# SERVICETEKNOTES

## TABLE OF CONTENTS

Figure 1.  
Composition and Film, respectively.

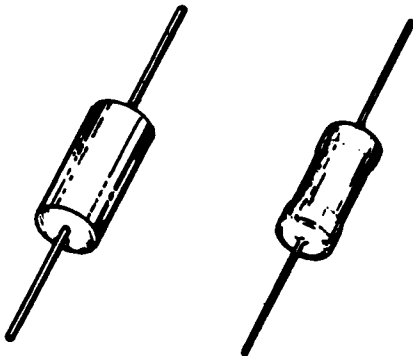
To correct this, only the carbon composition versions of the above part numbers should be used for these applications. Use of carbon film or metal film versions of these parts should be avoided. The distinction between composition and film parts is easily seen in the illustration below.

In high voltage applications, the film components have shown some distinct disadvantages. Metal film parts tend to open up without giving any visible evidence of their failure. Carbon film parts may drift in value due to migration of conductive particles (the Lorenzo effect). It is therefore advisable to avoid film resistors in any high voltage application.

Figure 1. CR566 Added.

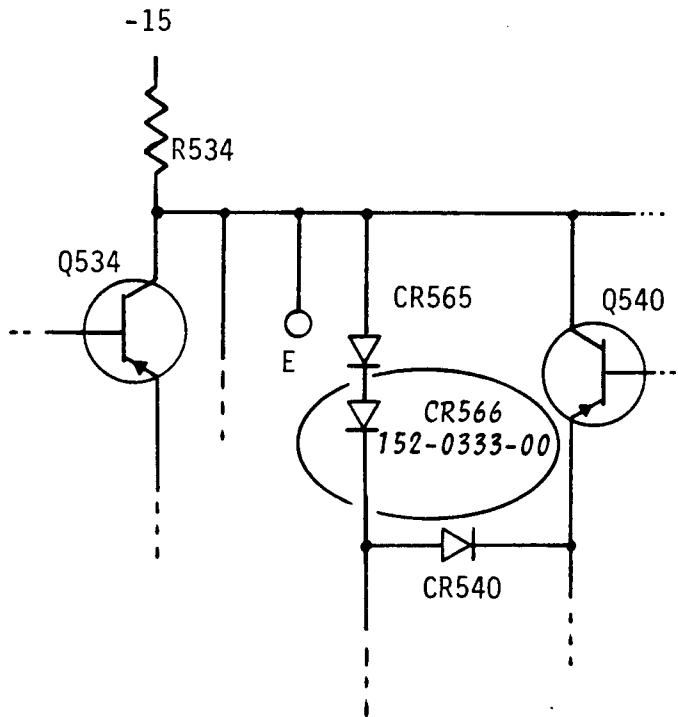
The 608 CRT specifications exceed the range of the Z-axis amplifier. As a result, setting cutoff on the 608 may not be possible with some CRTs.

To correct for this problem, a diode is added in series with CR565 in the Z-axis amplifier. The new diode, CR566, is part number 152-0333-00 and is mounted in tee-pee fashion. The part number of the Z-axis amplifier board rolls from 670-5216-02 to 670-5216-04 with this change.

*Printer Mechanism Assembly*

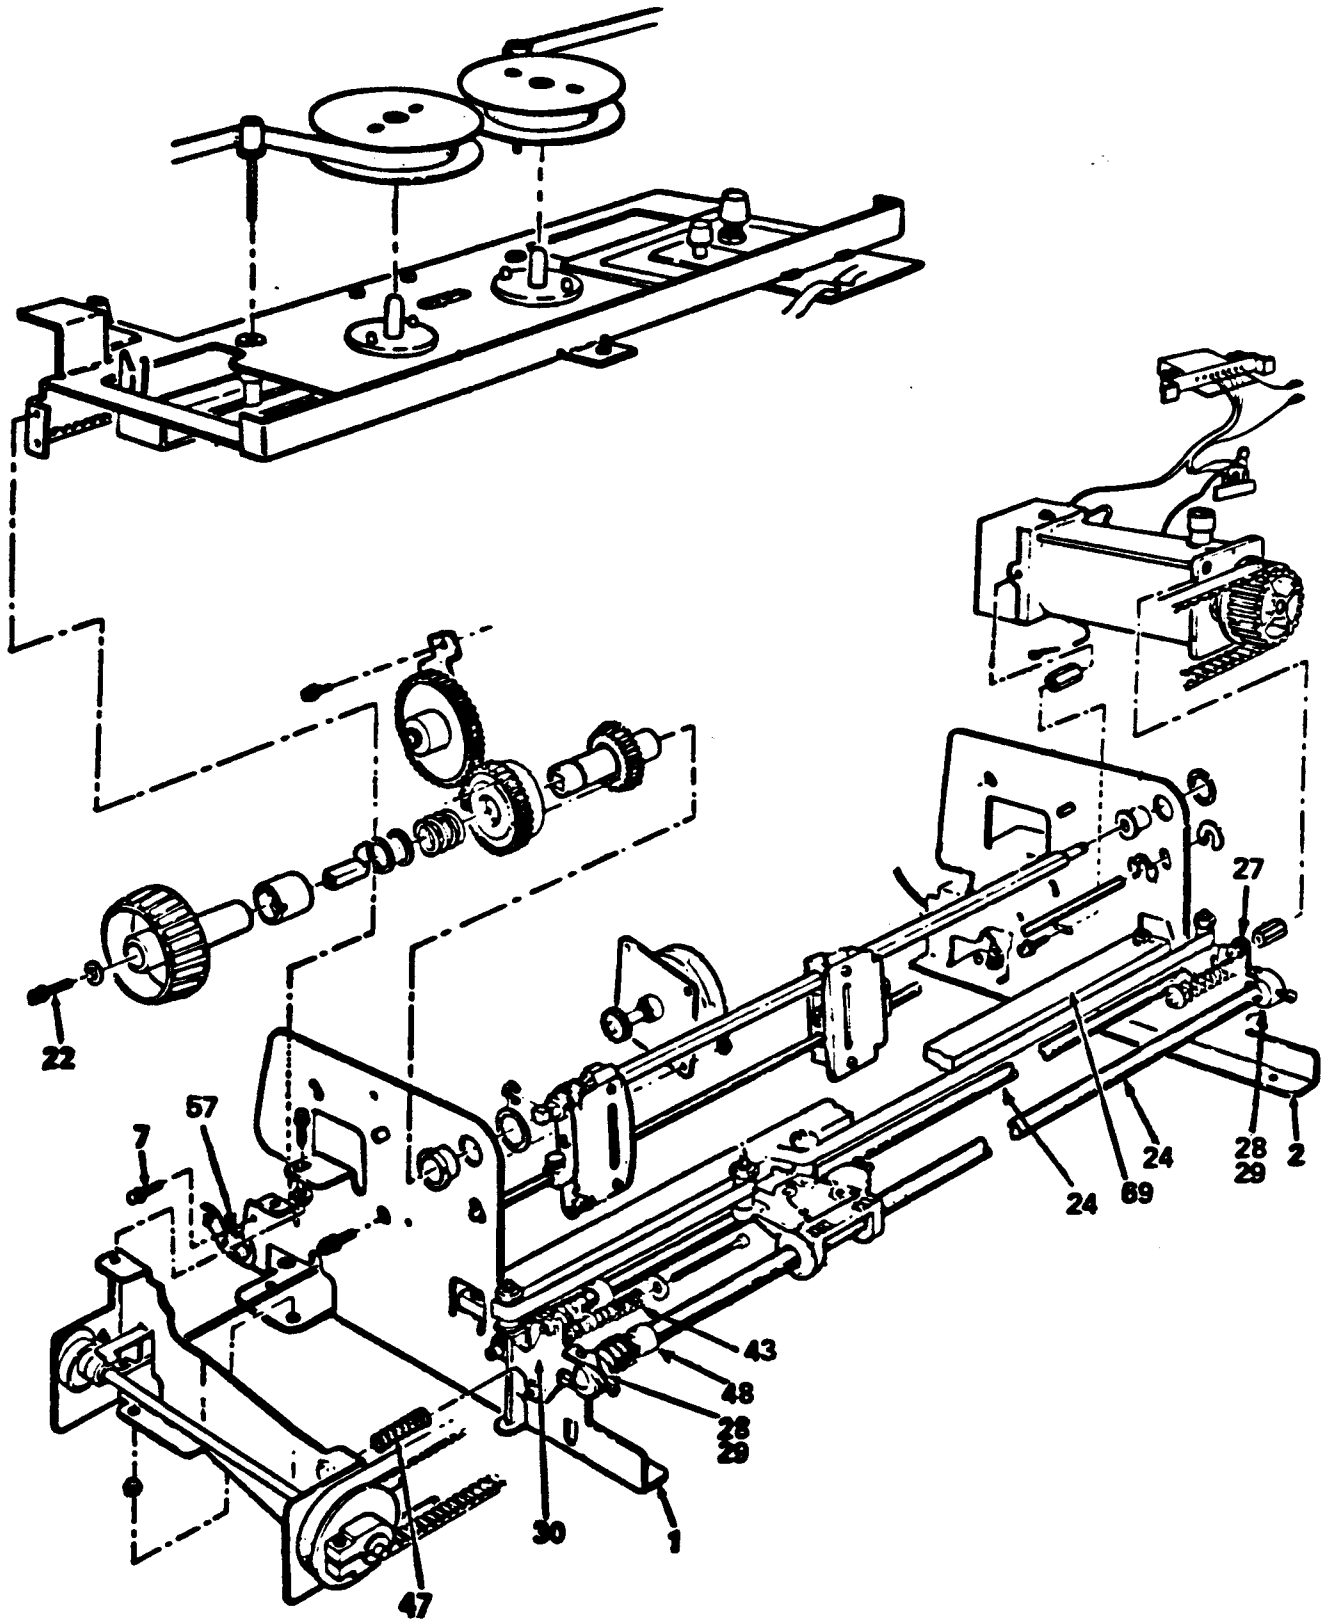
The 4641/4641-1/LP8200 is an OEM product that Tektronix purchases from Digital Equipment Corporation (LA-180). Until it was brought to our attention, we were unaware that DEC had modified the printer mechanism assembly. Furthermore, we are not able to establish a serial number break for the printer mechanism modification, because DEC has been shipping to Tektronix from a mixed stock of old and new version printers. The following drawing and parts list should be used in conjunction with the service manual when servicing the newer version printer.

The parts list only covers the parts that were affected by DEC's modification. Refer to the service manual to find part numbers for parts that were not changed. The parts affected by the change are not interchangeable between older and newer version printers. It is not recommended that these parts be purchased for local stock, they should only be ordered on an as needed basis.

<u>Index*</u>	<u>DEC Part Number</u>	<u>Tek Part Number</u>	<u>Description</u>
28	74-18137-00	118-3416-00	Clamp, Shaft 4641
29	90-06037-01	118-3417-00	Screw, Phil Pan HD #8-32x.38
30	74-18138-01	-----	Retainer, Shaft 4641
43	74-11816-00	118-3419-00	Spring, Carriage Bumper 4641
47	90-09578-00	-----	Spring, Compression 4641
48	74-13672-00	118-3421-00	Reservoir, Oil 4641
1	74-18142-00	118-3422-00	Plate Side, Left Hand
2	74-18142-01	118-3423-00	Plate Side, Right Hand
7,57	90-09988-01	-----	Screw, Sems Hex HD #6-32x.56 Cone
22	90-09984-00	-----	Screw, Sems Phil HD #6-32x.38 Cone
24	74-18139-00	118-0087-01	Shaft, Carriage 4641
27	74-18138-00	-----	Retainer, 4641 Shaft
--	49-01174-00	-----	Oil, 4641
69	74-17937-00	118-3428-00	Bar, Print, Assembly

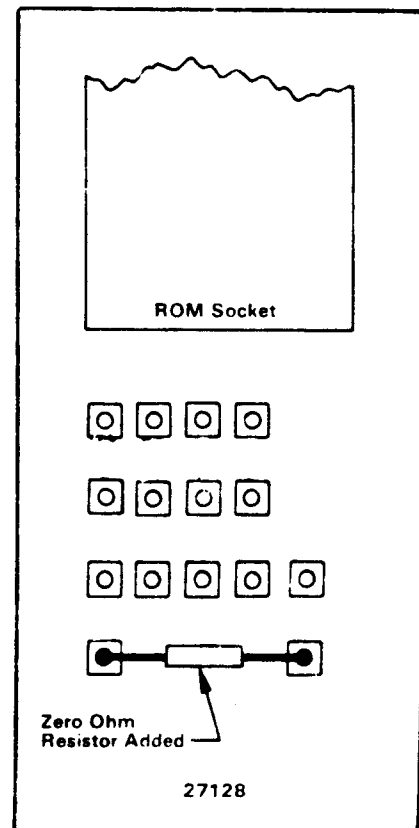
A wire strap or zero ohm resistor must be added to each chip location of the System ROM board before they will accept the 27128 devices. The strap should be added as shown in the following illustration:

NOTE: This strap enables address line 13 to pin 26 of the corresponding ROM socket. Pin 26 of a 2764 EPROM is not connected internally; therefore a socket that has been modified to accept 27128 EPROMs will work fine with a 2764. New System ROM boards shipped from Manufacturing and Board Exchange have zero ohm resistors installed for all ROM locations.
